NOTICE OF VIOLATION

On May 23, 2024, Energy Safety conducted an inspection of PacifiCorp's WMP initiatives in the vicinity of the city of Fort Jones, California. The inspection report is enclosed herewith. Energy Safety found the following violation(s):

INSPECTION REPORT

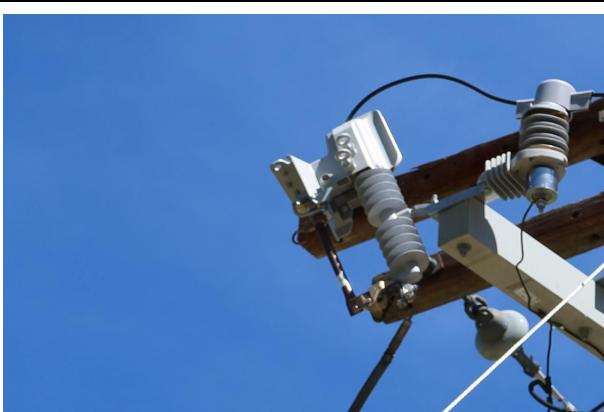
On pole ID 06243009.0028303 at 11724 Eastside Rd, Fort Jones, CA, 96032, USA, 41.604880743129, -122.841787587528, the inspector observed that one of the fuses in place is a non-exempt expulsion fuse. The inspector's observation is documented in Violation 1 photographs, which are attachments to this report. Photo numbers Item6IA1Img1 and Item6IA1Img2 depict a non-exempt expulsion fuse.

1. PacifiCorp's WMP 8.1.2.12 - Expulsion Fuse Replacement work was identified as complete at this location.
2. Energy Safety observed a non-exempt expulsion fuse.
